**ENGINEERING, OPERATIONS AND PLANNING COMMITTEE MEETING  
AGENDA**

**DATE:** January 16, 2024  
**TO:** Engineering, Operations and Planning Committee  
**FROM:** Linda Jadeski, Assistant General Manager  
**SUBJECT:** CHANGE ORDER NO. 4 WITH PCL CONSTRUCTION, INC. FOR THE OLIVER P. ROEMER WATER FILTRATION FACILITY UPGRADE AND EXPANSION PROJECT

CHANGE ORDER

Order No. 4  
Date 1/8/2024  
Agreement Date 10/31/2022  
Sheet 1 of 2

Client	WEST VALLEY WATER DISTRICT
Project	OLIVER P. ROEMER WATER FILTRATION FACILITY 2021 EXPANSION - PHASE I
Title	YARD PIPING ENLARGED PLANS AND SECTIONS
Project No.	11214029
Original Size	ANSI D
Sheet No.	C-104
Sheet	9 of 88

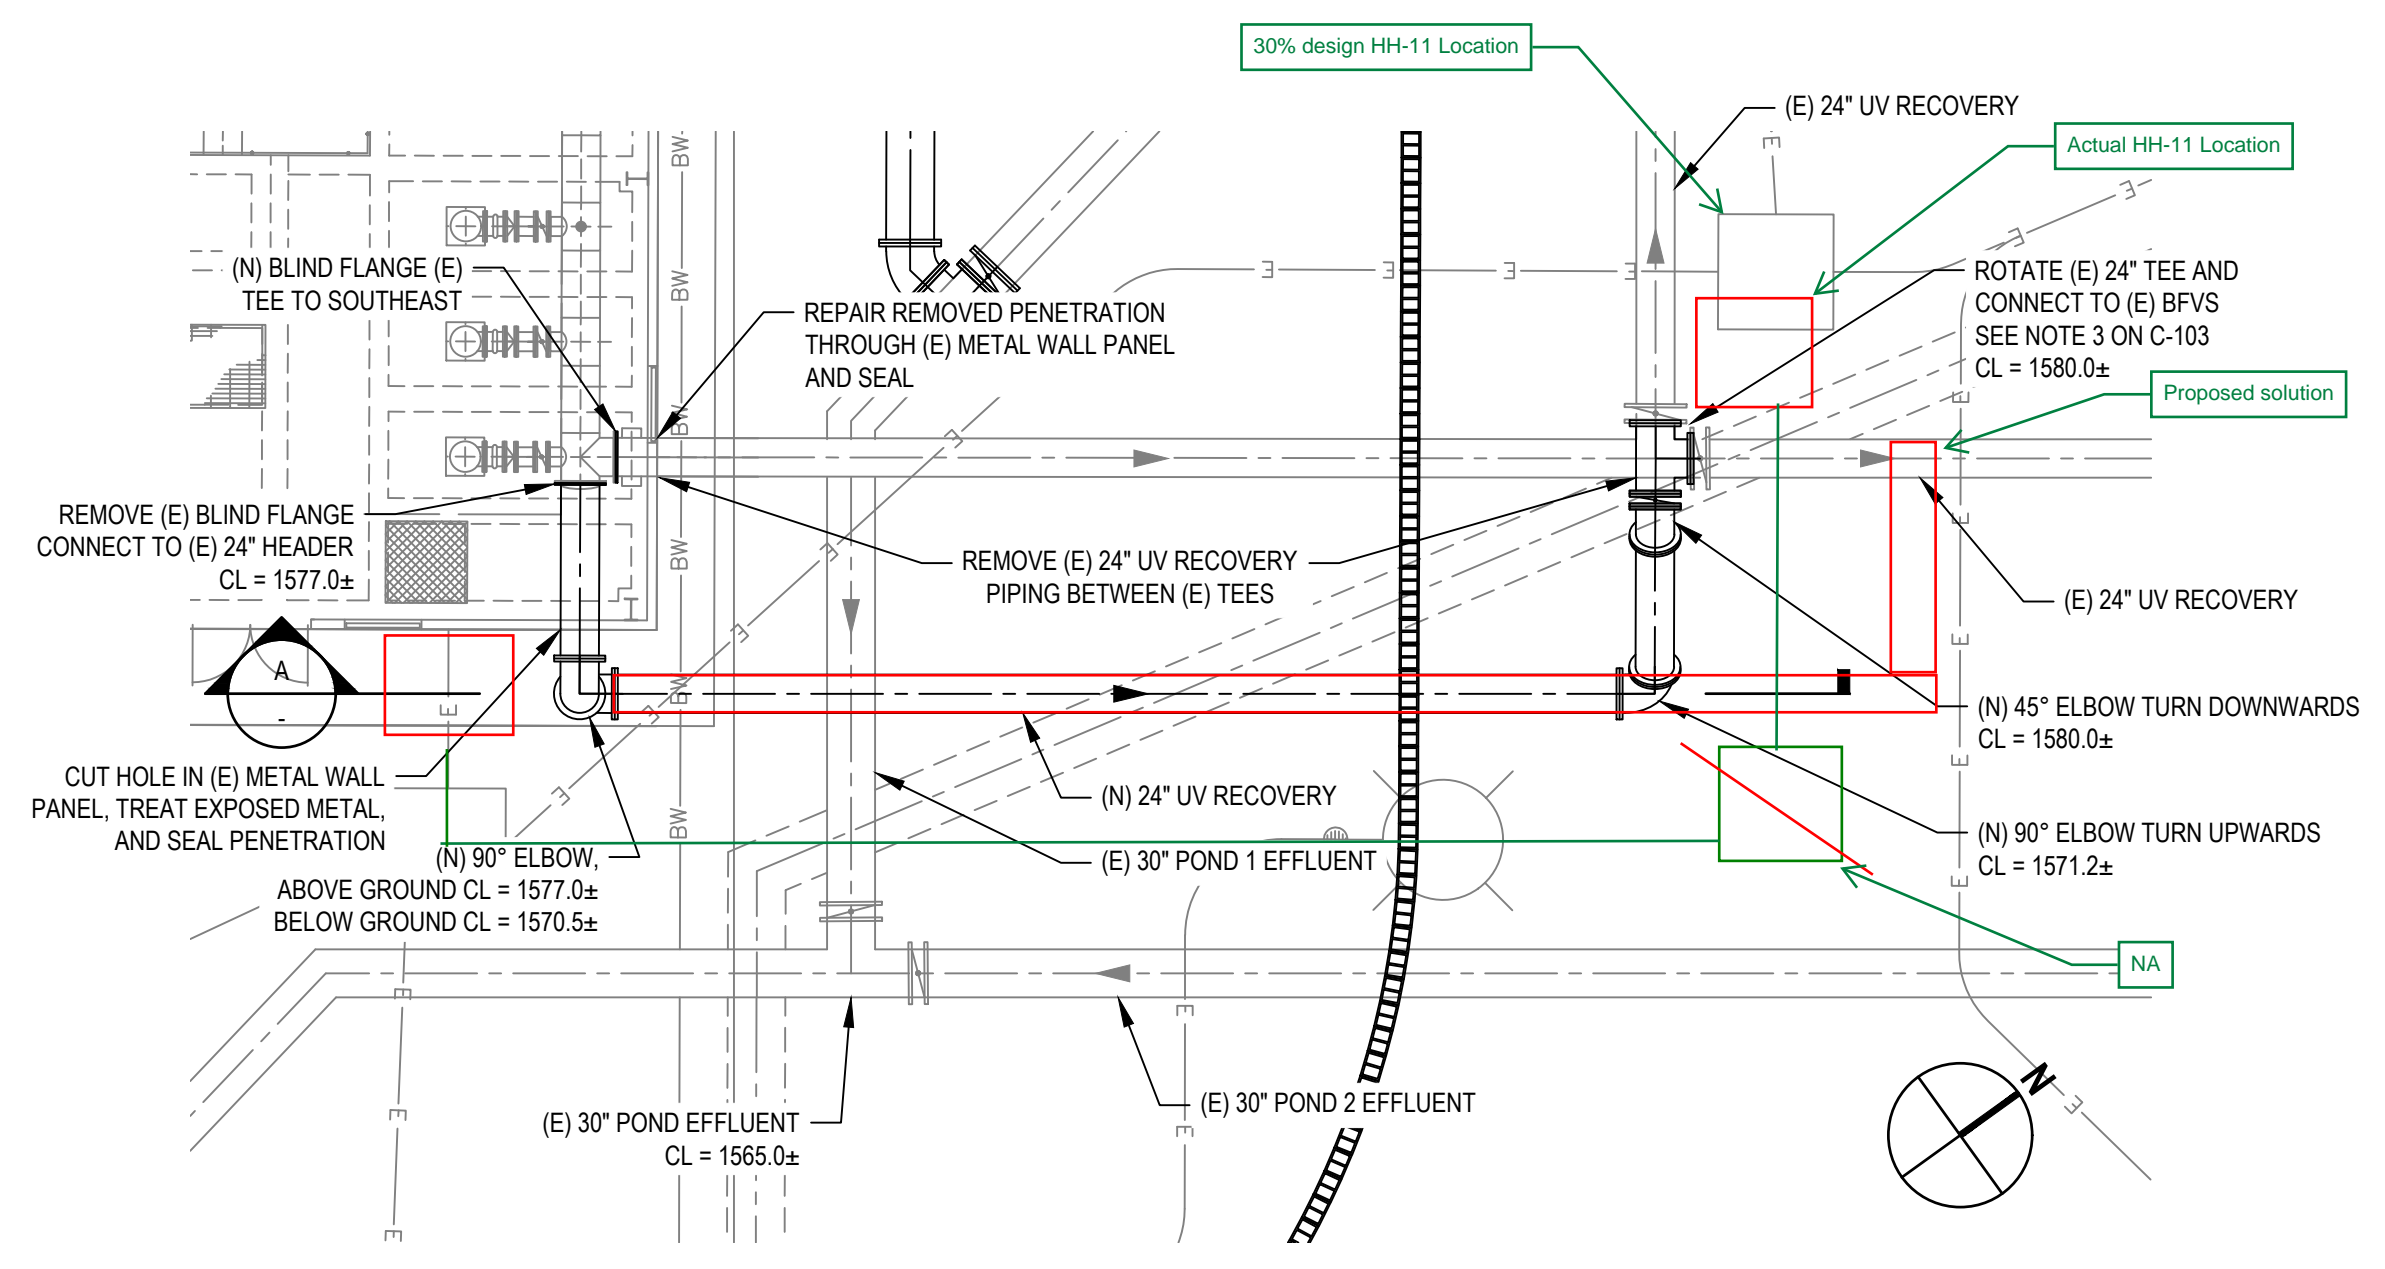
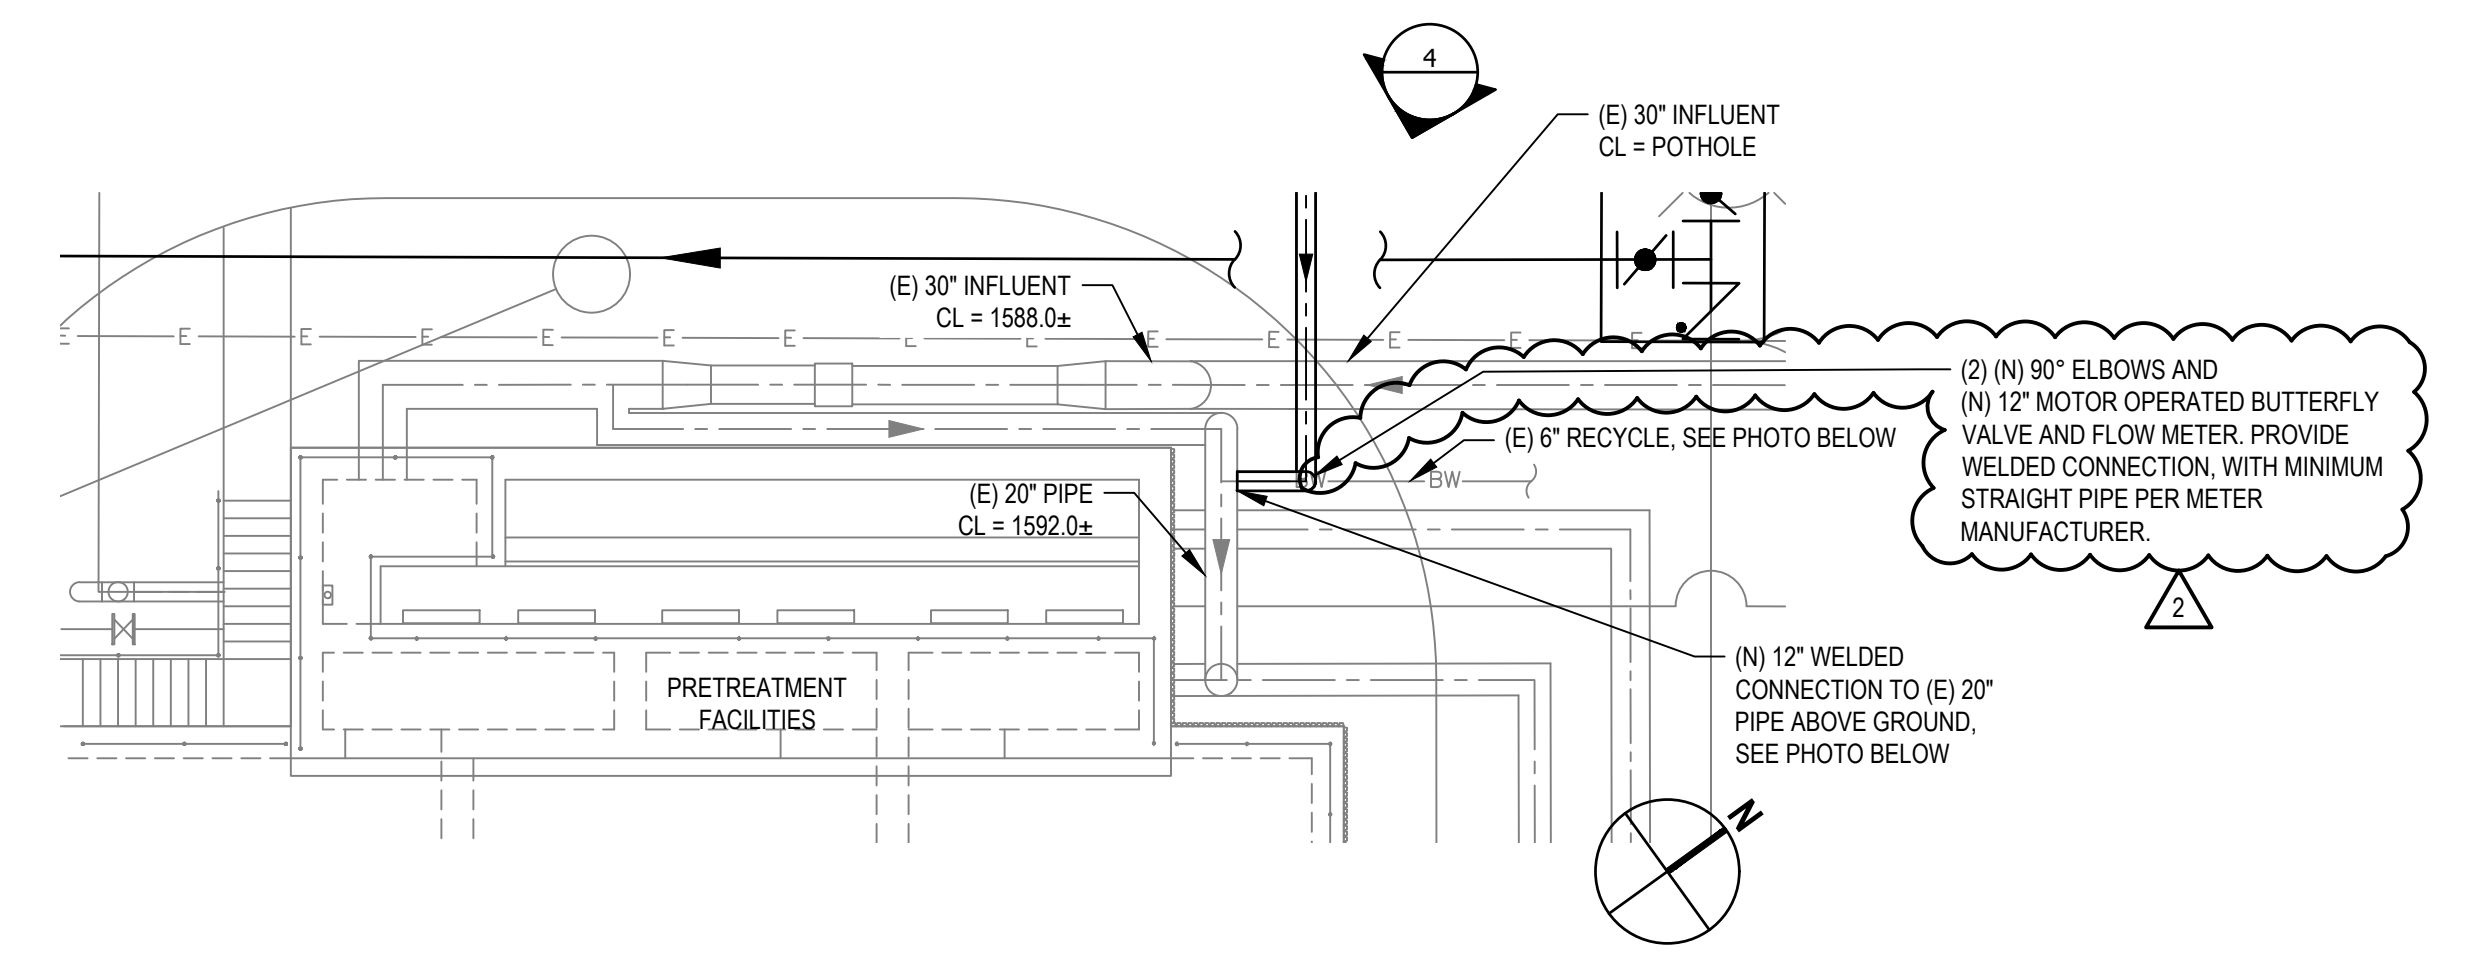
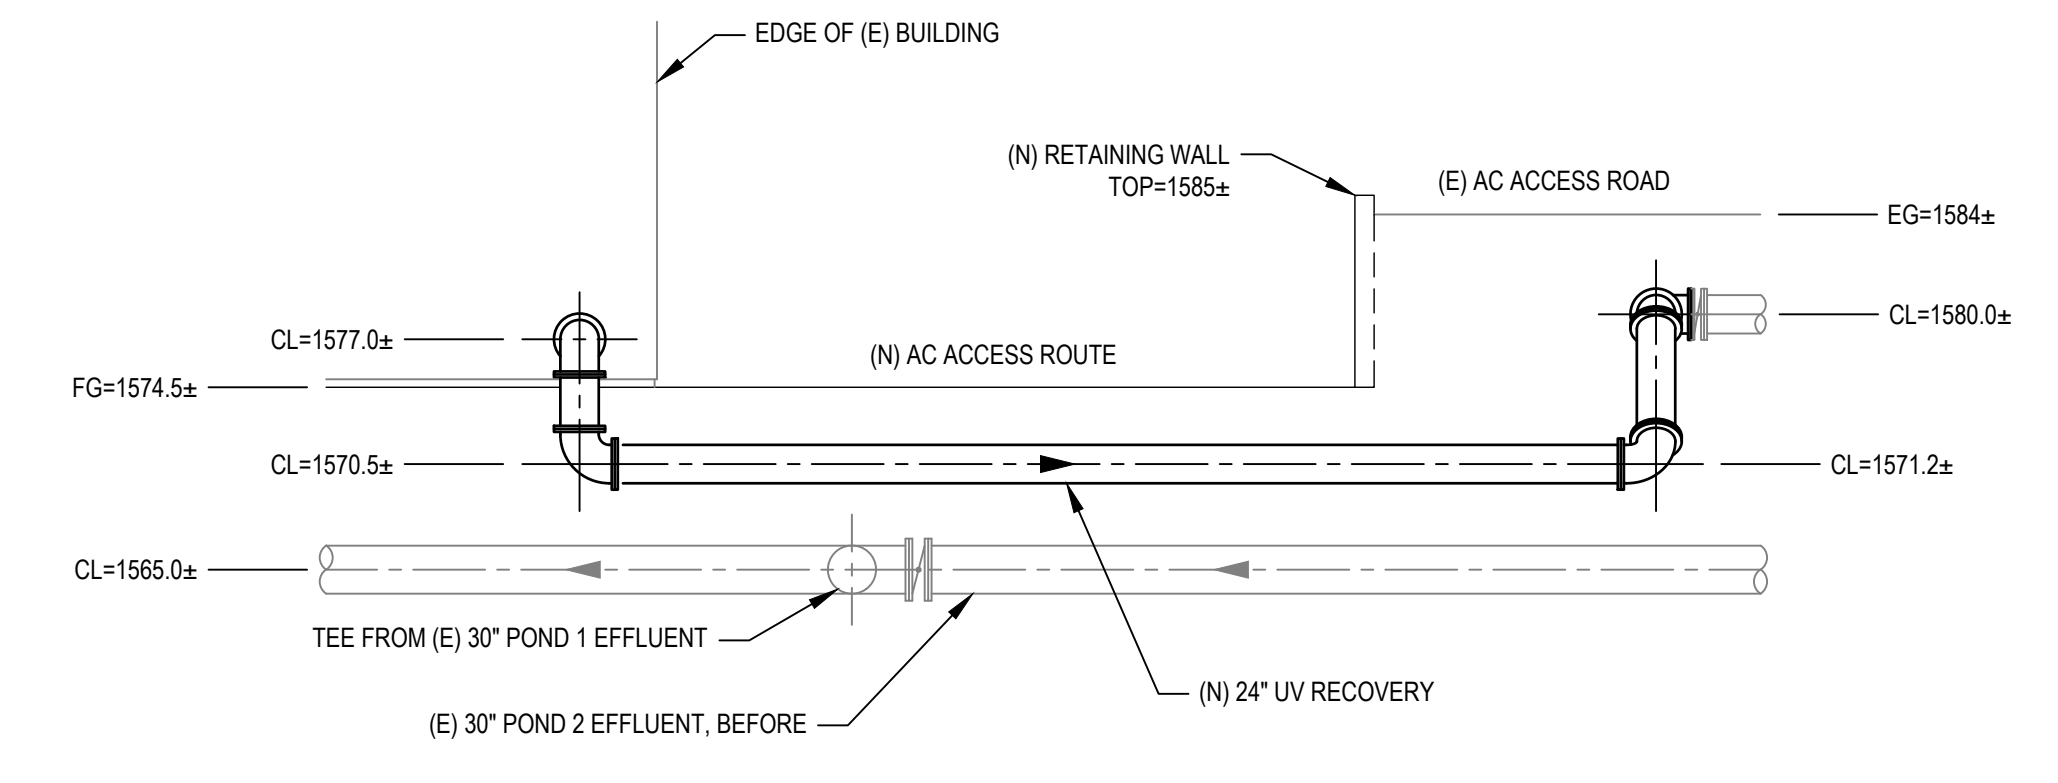
2. The 30% design drawing S-101 indicates that only one of five utilities crossing the new retaining wall needed to be rerouted. Additionally, civil drawing C-104 indicates that the 24" UV recovery line needs to be rerouted at a deeper elevation in order to avoid conflicting with the new wall. The 30% drawing C-104/1 clearly illustrates both the new 24" line and existing ductbank coexisting in the area as the design intent. This is corroborated by cut section A, which depicts the proposed new 24" UV Recovery line with an approximate three-foot coverage. Given the ductbank section being approximately 3'-0" deep, there would be clearly no space for it to be placed above the 24" UV recovery line, which is another reason for PCL to have assumed that the existing ductbank was running at a much deeper elevation rather than the 2-foot minimum coverage indicated in the record drawings. Based on field investigations performed after the project had been awarded to PCL, it was discovered that the ductbank would not only conflict with the new retaining wall but also with the proposed 24" UV recovery reroute and need to be rerouted.

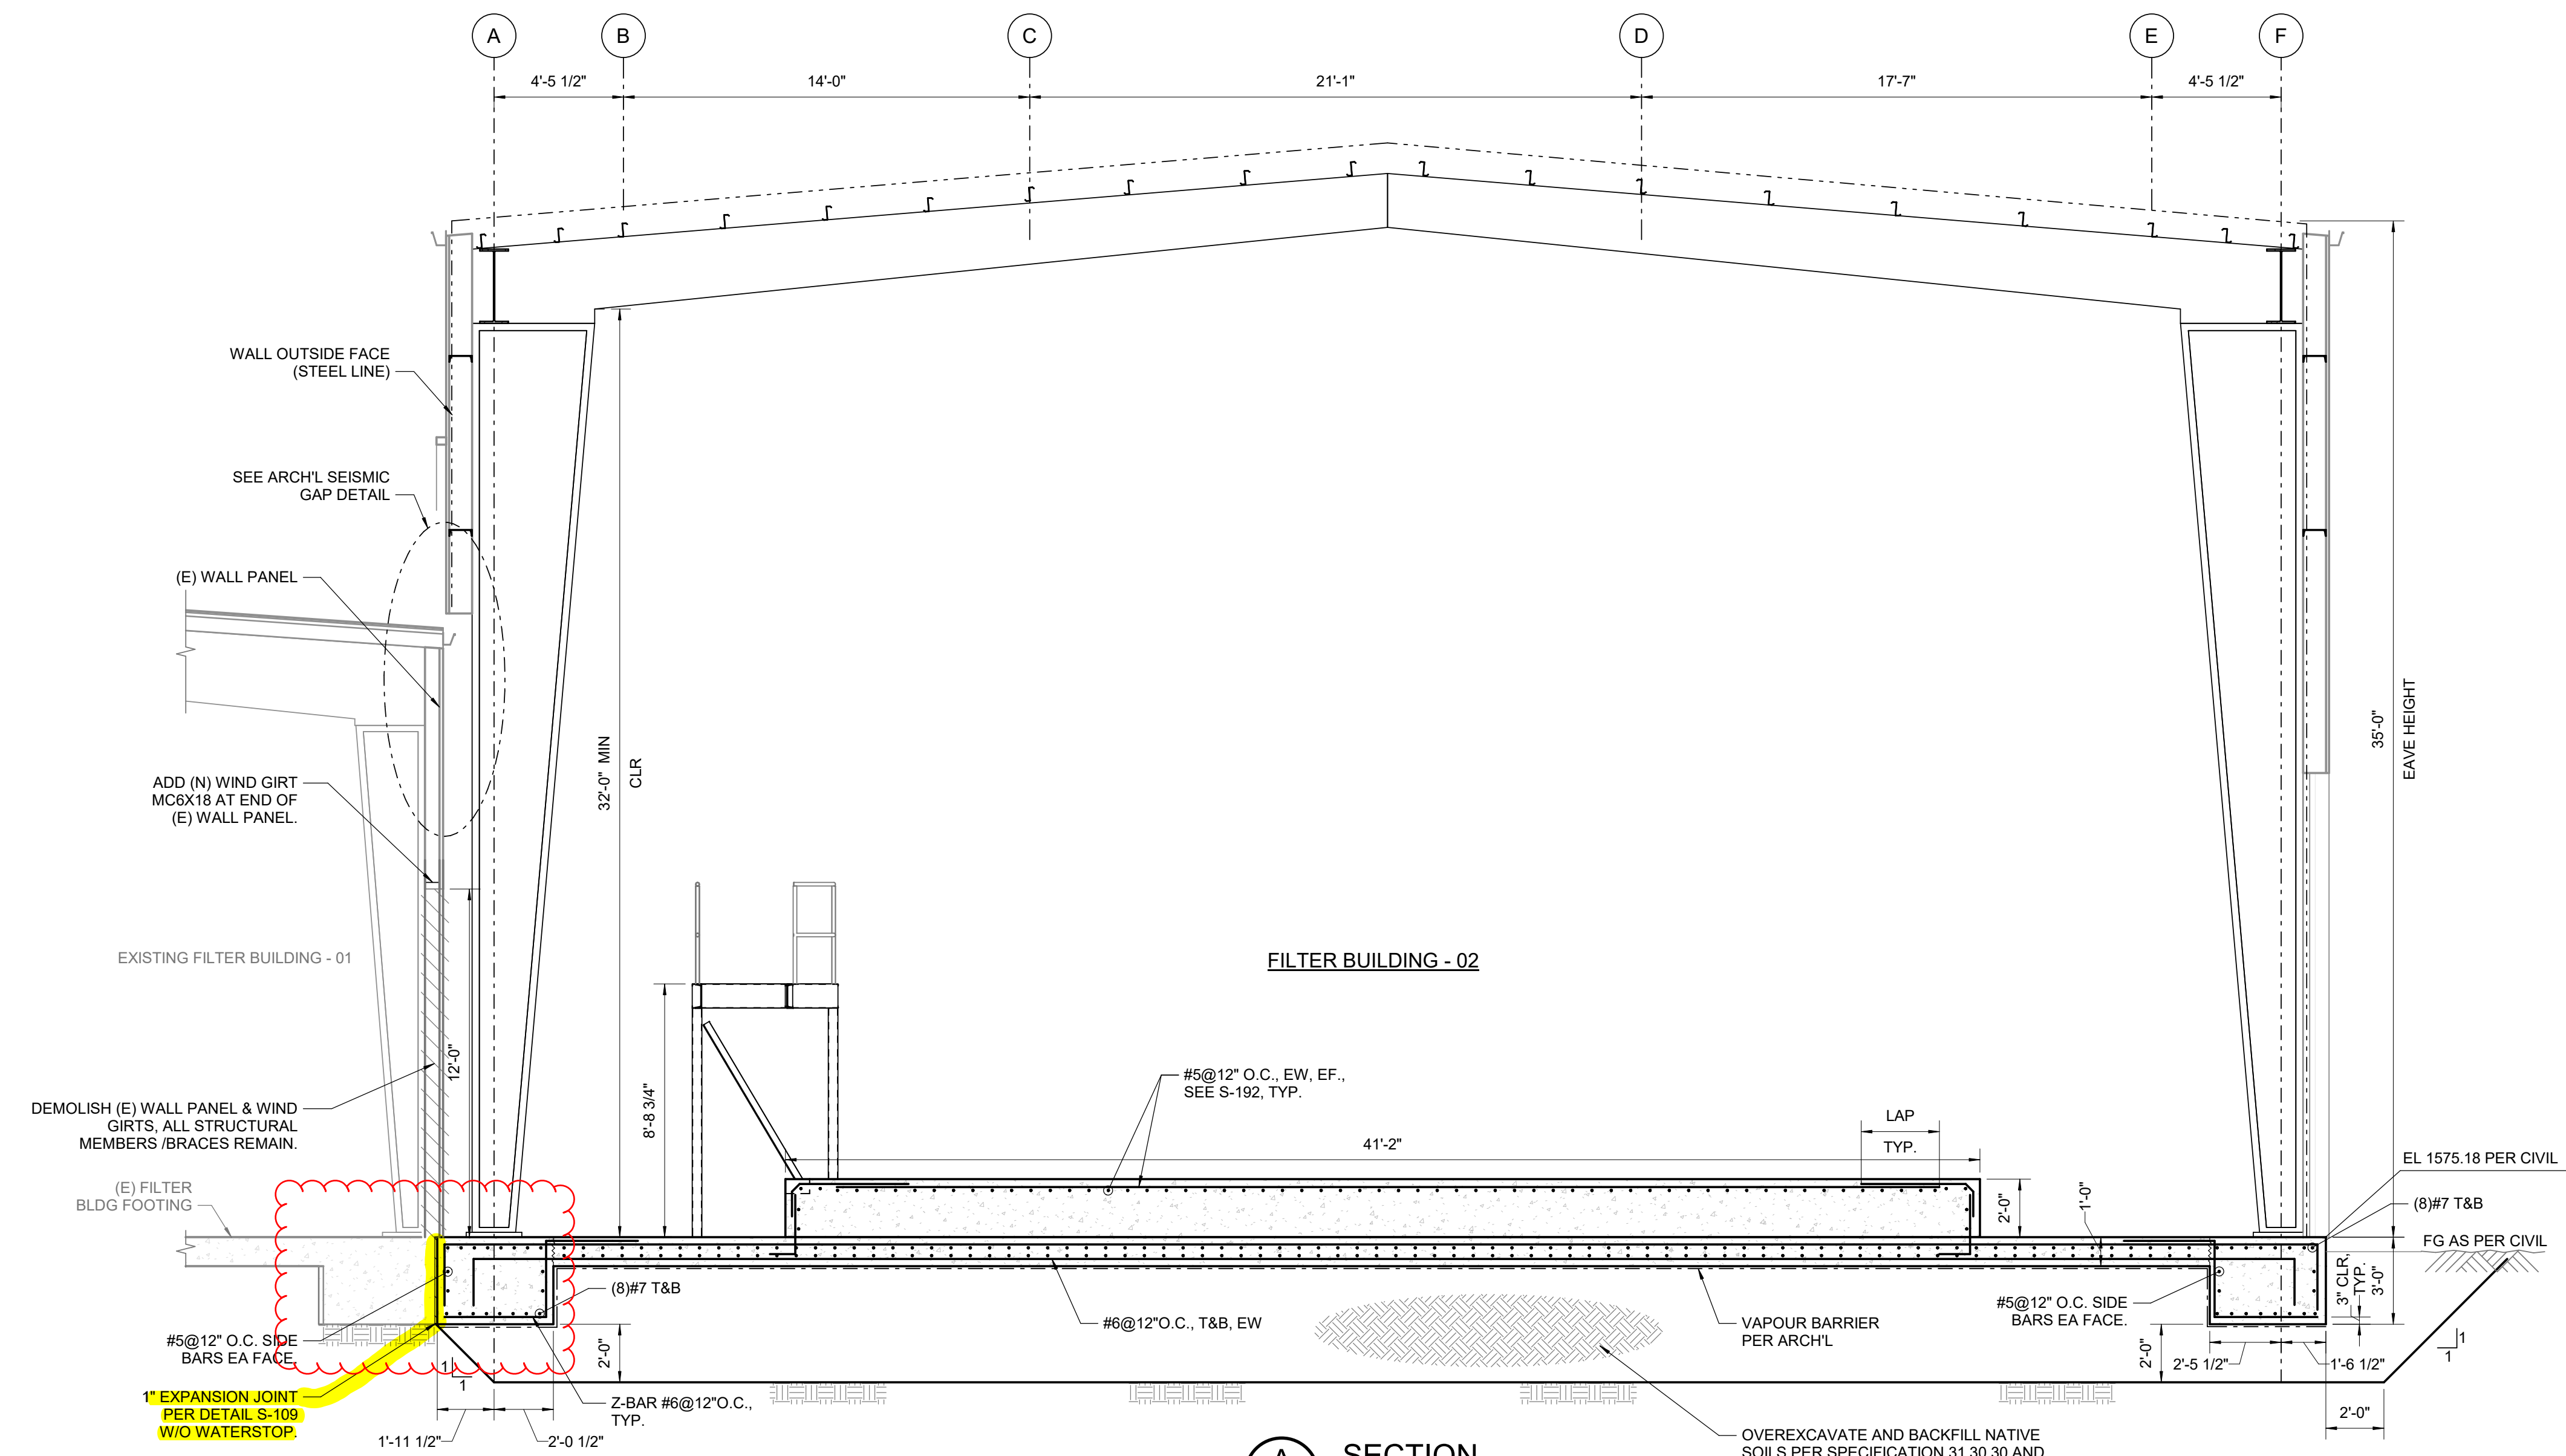
1. The existing building foundation protrudes into the footprint of the new Filter Building 2 slab.
2. The new expansion joint per S-109 / detail S-109 cannot be constructed at the uneven sections.

As we discussed, it is acceptable to saw cut the uneven existing footing edge to level flush the formed footing edge. Please stop cutting if any existing rebar occurs.
